# Service Bulletin

Bulletin No.: PI0235F

**Subject:** Exhaust Leak or Vibration/Rattle Noise at Approximately 900 RPM, Fuel Smell, White Smoke, Oily Substance on Exhaust Downpipe

**Models:** 2011-2013 Chevrolet Express 2500/3500/4500, Silverado 2500HD/3500HD  
2011-2013 GMC Savana 2500/3500/4500, Sierra 2500HD/3500HD  
Equipped with 6.6L Duramax™ Diesel Engine (RPOs LML or LGH)

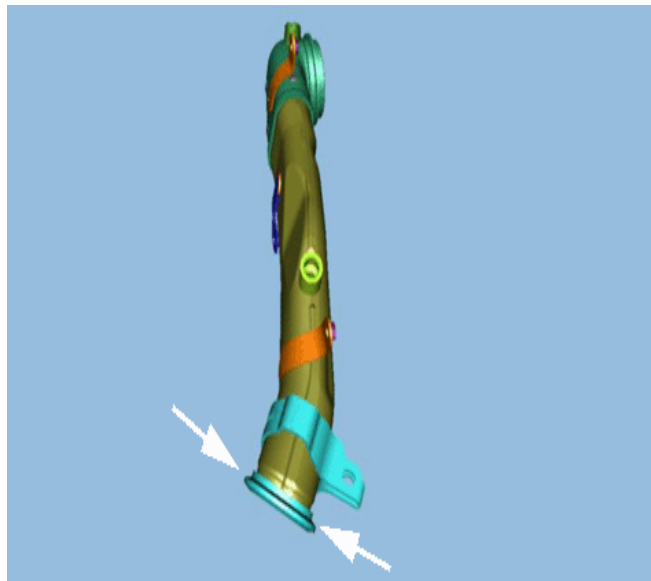
If the above alignment procedure does not correct the condition, the turbocharger exhaust pipe may need to be replaced on trucks built prior to the breakpoints listed below with an updated turbocharger exhaust pipe with a pilot flange. If the turbocharger exhaust pipe has the new flange, you should not need to replace it. Refer to the Turbocharger Exhaust Pipe Replacement procedure in SI.

**Note:** The illustration above is the updated turbocharger exhaust pipe with a pilot flange.

**Note:** The illustration above is the turbocharger exhaust pipe without a pilot flange.
